South Carolina Electric and Gas
V. C. Summer Nuclear Station, Units 2 & 3
COL Application

Part 4

Technical Specifications

PLANT SPECIFIC TECHNICAL SPECIFICATIONS (PSTS)

Figure 4.1-1 Low Population Zone Map

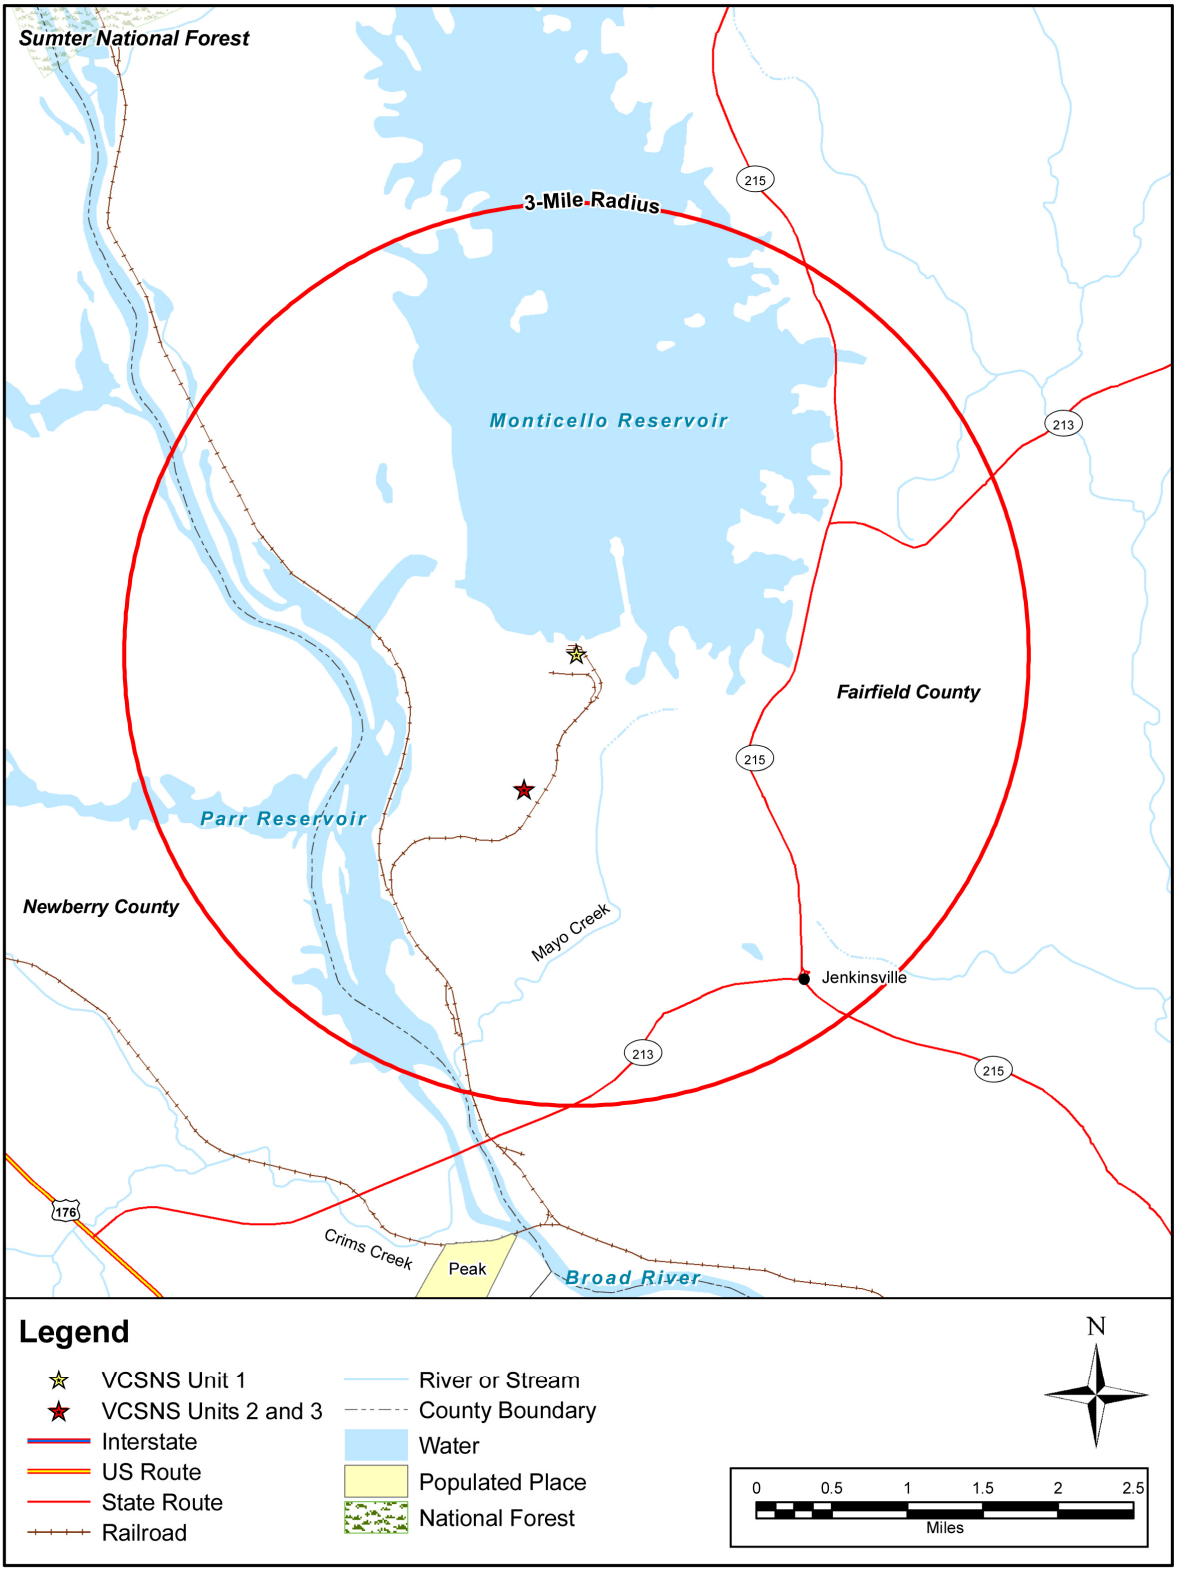
Replace the bracketed information in the GTS with the following:
The LPZ is defined by the 3 mile radius from VCSNS Unit 1 as shown in Figure 4.1-1.

Figure 4.1-2 Exclusion Area Boundary and Site Boundary Map

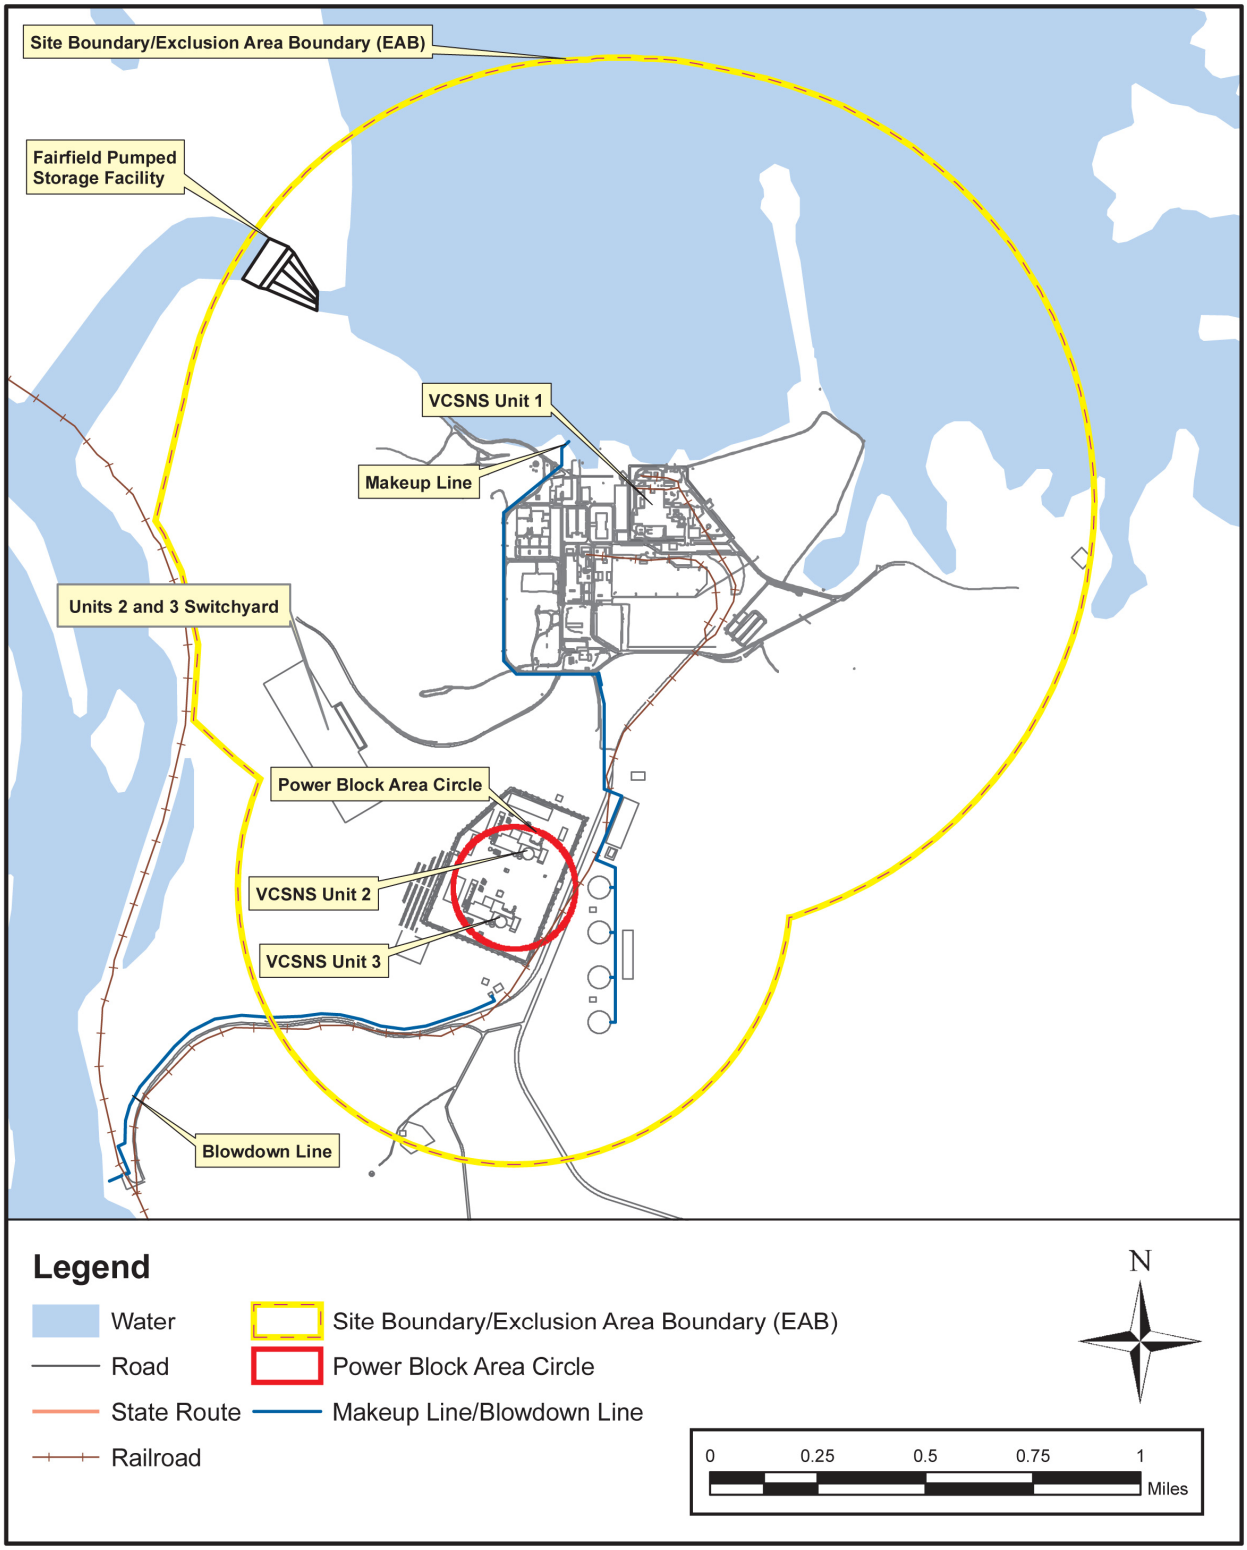
Replace the bracketed information in the GTS with the following:
The Site Boundary is shown in Figure 4.1-2. The Exclusion Area Boundary is shown in Figure 4.1-2.
